**City of Newton, Massachusetts**  
 Department of Planning and Development

DATE: October 12, 2012

SUBJECT: #258-12 BH NORMANDY RIVERSIDE, LLC/MASSACHUSETTS BAY TRANSPORTATION AUTHORITY petition for a change of zone to Mixed Use 3/Transit Oriented District for a portion of land located at 327 Grove Street, also identified as Section 42, Block 11, Lot 3A, currently zoned Public Use.

#258-12(2) BH NORMANDY RIVERSIDE, LLC/MASSACHUSETTS BAY TRANSPORTATION AUTHORITY petition for a SPECIAL PERMIT/SITE PLAN APPROVAL to construct a mixed use, transit-oriented development including an office building of approximately 225,000 sq. ft., a residential building containing 290 apartments with 5,000 sq. ft. of retail space, a three story building containing approximately 15,000 sq. ft. of retail space and approximately 8,000 sq. ft. of community space, and related site improvements; to permit office use on the ground floor, medical office use, retail and personal establishments of more than 5,000 sq. ft., eating and drinking establishments of more than 5,000 sq. ft., retail banking and financial services, and health club establishments on the ground floor; and reduced minimum setbacks of side s

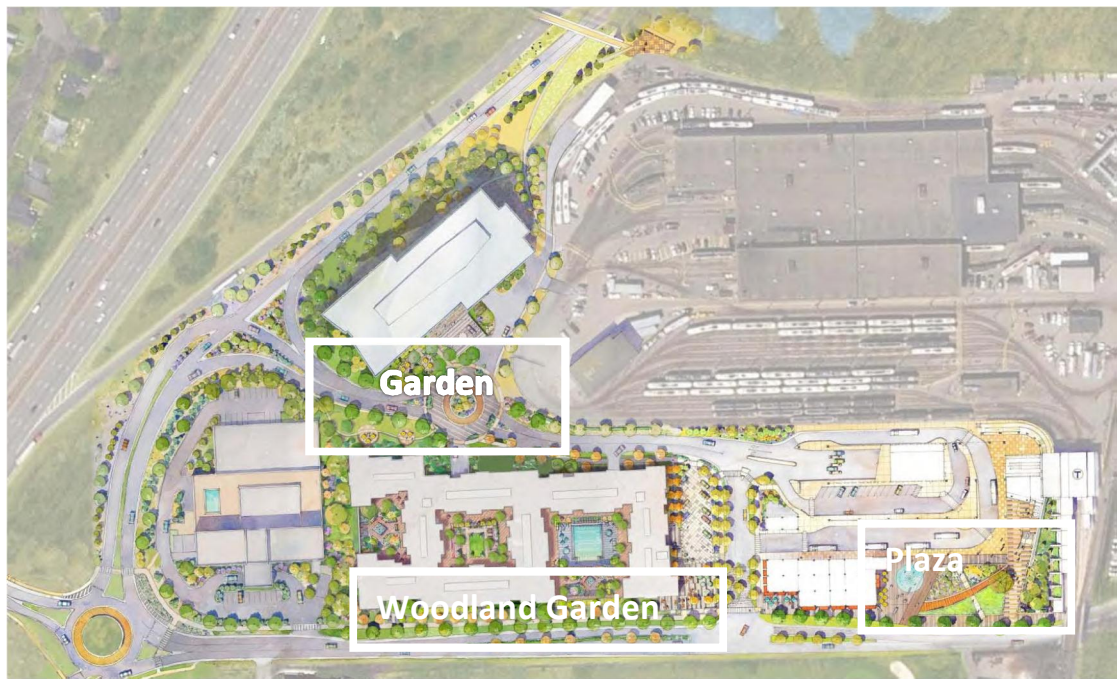
The use of Zipcars also can encourage people to downsize from two cars to one or to eliminate car-ownership entirely, as they provide the option for auto use without the ongoing maintenance and cost of storage. Staff recommends the petitioner consider

locating one or more on this site.
